Proposal Request

Project:
Intermountain Healthcare Lake Park North Level 1 Remodel
2545 College Drive
Murray, Utah 84123

Date: 07/21/2022
Proposal Request
PR # 01

Purpose for the Proposal Request: These modifications resulted from sewer district review comments, owner requests and contractor questions/ issues discovered during construction.

1 MECHANICAL PLAN DEMO LEVEL 1
MD101 | SCALE: 1/8" = 1'-0"

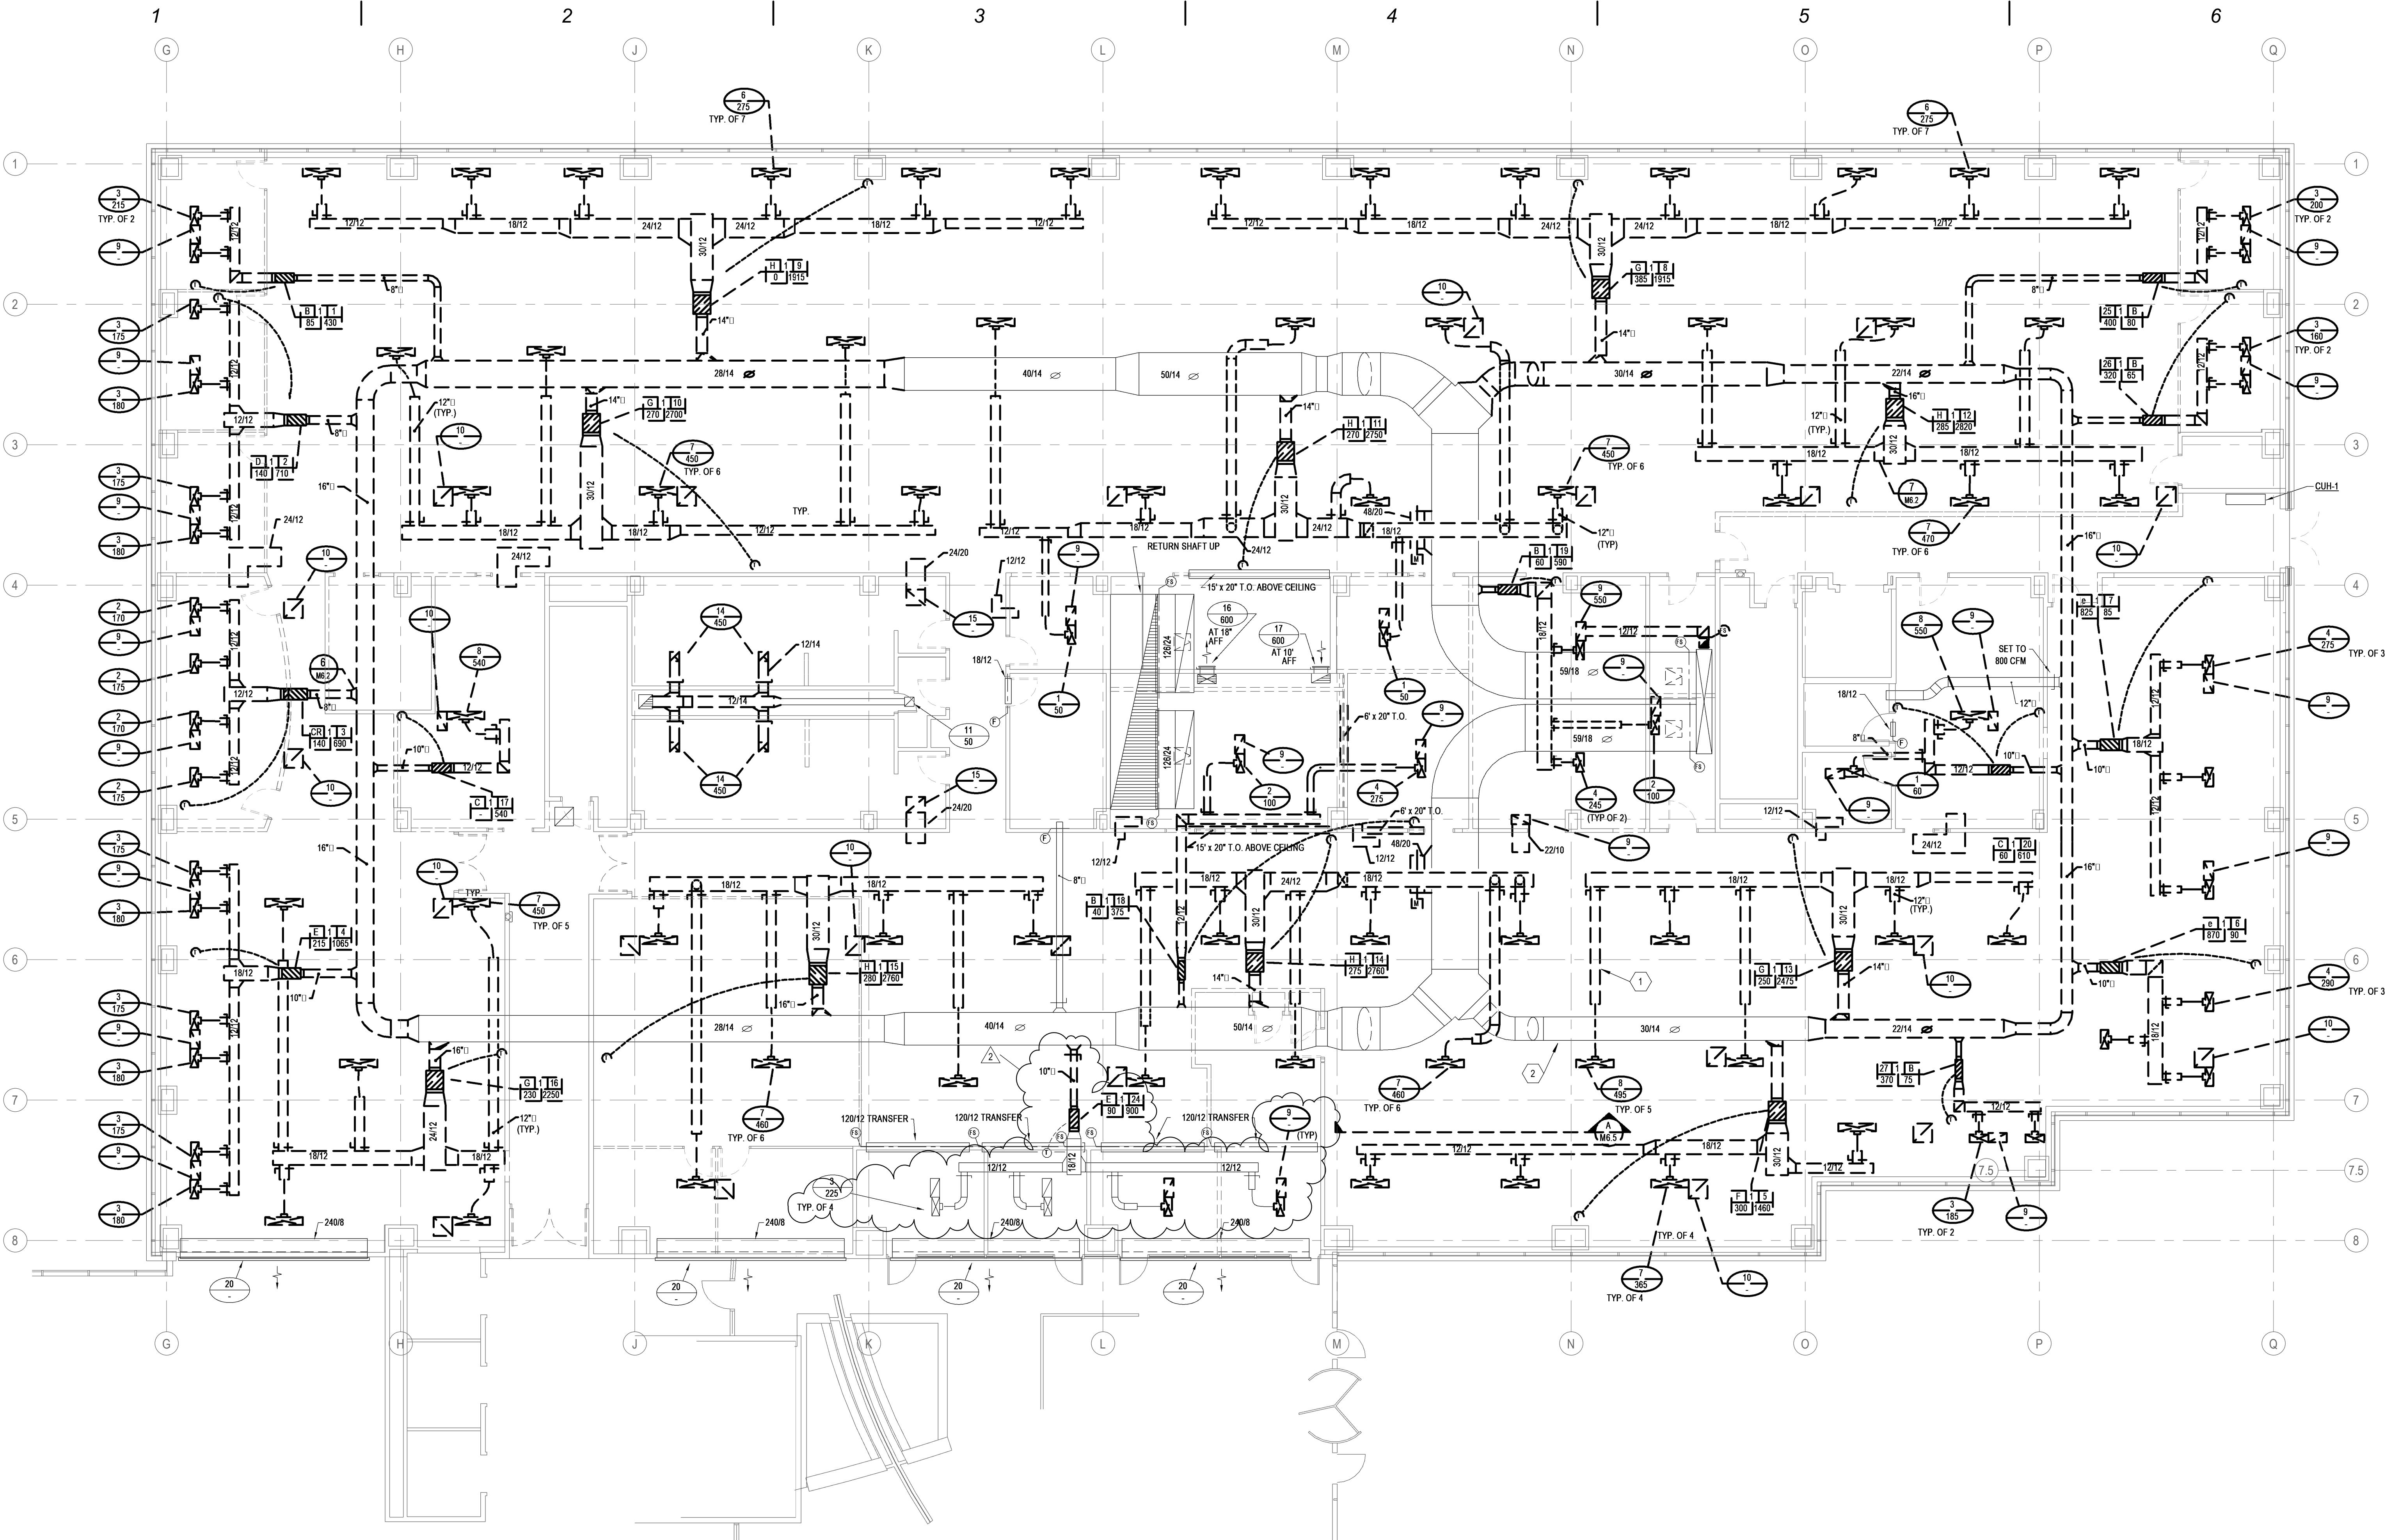
3. **RFI #03:** Per RFI #03, there were questions regarding how to fit new ductwork through existing openings in steel beams, whether to raise existing floor cleanouts into the raised concrete floor, and how to treat the ductwork into the security areas. The ducts have been narrowed to fit the beams, the floor cleanouts are to be raised and the ductwork has been clarified. See the original response to RFI #03 and the revised MD101, MH101, and MH601.
